DEFENSE LOGISTICS AGENCY
LAND AND MARITIME
P.O. BOX 3990
COLUMBUS, OHIO 43218-3990

SUBJECT: Engineering Practices Study: Lead Requirements for MIL-PRF-49470.

Project number: 5910-2014-013.

Coplanarity

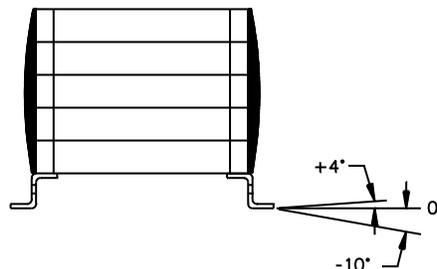
This proposed coplanarity requirement is intended for lead styles “L” and “J” to ensure that the lead bends are in one plane. The maximum deviation limit of .003 inches originates from NASA STD 8739.2 (Workmanship Standard for Surface Mount Technology) (canceled).

Foot Angle

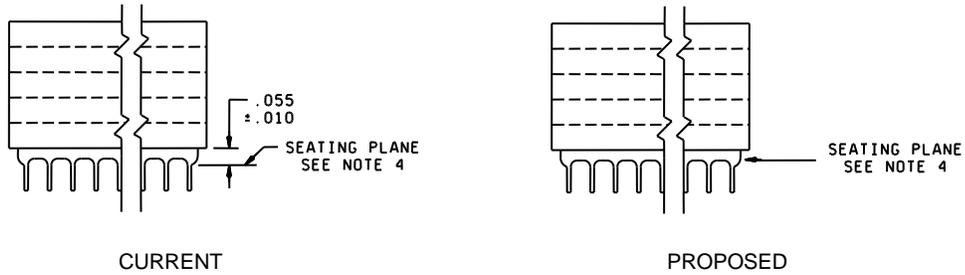
This proposed foot angle requirement is also intended for lead styles “L” and “J” to ensure that the lead bends are horizontal. A maximum deviation of +4°, -10° was suggested by a manufacturer.

1. Foot angle shall be +4°, -10° from the plane formed by the bottom of the chip stack.
